Office Action Summary	Application No. 10/576,610	Applicant(s) YAMAUCHI, TOSHIO	
	Examiner EMILY M. MORGAN	Art Unit 3677

DETAILED ACTION

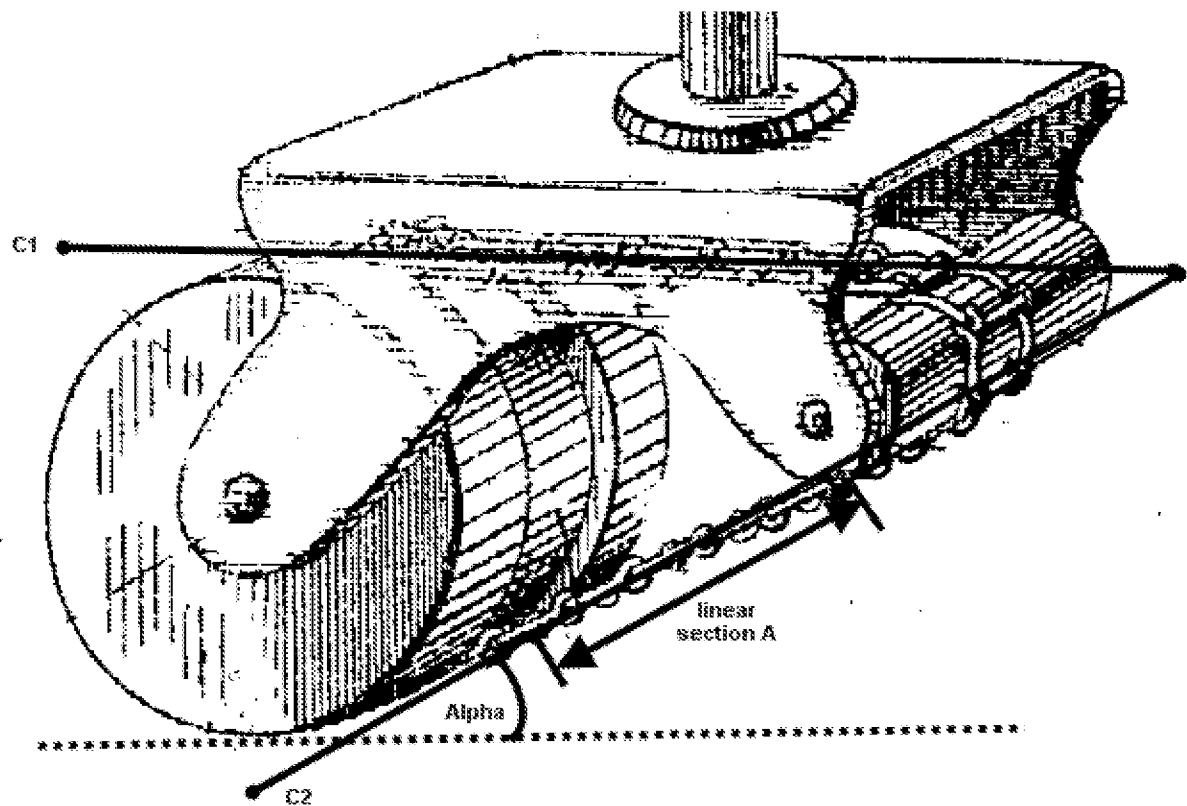
Claims 1 and 16 are rejected under 35 U.S.C. 103(a) as being unpatentable over patent 1066754 to Rison in view of patent 4752105 to Barnard.

Regarding claim 1, Rison discloses a caster (figure, shown below) comprising: first 19 and second 21 wheels disposed forward and back and an endless wrap-around member 22 wrapped around the first 19 and second 21 wheels, the first and second wheels having common tangents C1 and C2, the common tangent C2 having an angle (alpha) with respect to a ground surface, wherein the wraparound member 22 is a continuous endless belt formed by connecting a plurality of pieces (links, line 56) via a plurality of connecting members, the wraparound member having a linear portion A formed along at least the common tangent C2 of the wheels (all shown below). Rison does not disclose the specified structure of the wraparound member.

Barnard discloses wrap around tread (figure 2) wherein the tread is made of pieces 40 independently formed as a body having a connecting section 39 (figure 8) that faces the adjacent pieces of either side thereof, a contacting section 40.3 and 40.4 on an outer peripheral side (figure 4) of the connecting section 39, and a guide wall 12.2 on an inner peripheral side of the connecting section 39 (figure 3), and when viewed along an axis of rotation of the wheels, each of the contacting sections is seen as a linear section that extends parallel to the contacting sections of the adjacent pieces (figure 2), and that is perpendicular to the linear portion A of the common tangent C2 of the wheels (each piece is seeming perpendicular to the linear length between the two wheels, figure 2), wherein each of the guide walls 12.2 on the inner peripheral side of the contacting section 39 includes an inclined surface section (creating acute angle 48),

the inclined surface section being adapted to form a groove that is substantially V-shaped between each of the adjacent pieces (figure 2), thereby enabling the wraparound member to bend along an outer periphery of each of the first and second wheels (figure 2), wherein connecting sections 39 are provided between the contacting section 40.3 and 40.4 and the guide wall 12.2 of each of the pieces, and wherein the plurality of pieces 40 are connected by the plurality of connecting members (wires 41, figure 3) which extend, respectively, through the connecting hole 43 provided in each of the pieces.

It would have been obvious to one of ordinary skill in the art at the time of the invention to apply the treads of Barnard in place of the links of Rison, motivated by the desire to further enable the caster of Rison to carry itself over inequalities in the floor (line 13) just as Barnard uses the tread to go over obstacles in the land. Rison also discloses that other flexible members may be applicable to the caster disclosed (lines 55-60). This would be an easy exchange from links to the Barnard tread in that the wheels of Rison are centrally grooved, which would accommodate the central guide pieces of Barnard.

Since the contacting sections of the adjacent pieces abut respectively against each other along a linear portion (shown in figure 2), when the pieces are applied to the Rison caster, the effect would be the same along the linear portion of tangent C2. The Barnard applied tread along the linear portion A of the common tangent C2 is capable maintaining a linear condition and is prevented from being dented, so that even when the linear portion A is pushed by a force from an outside, the linear portion A is capable
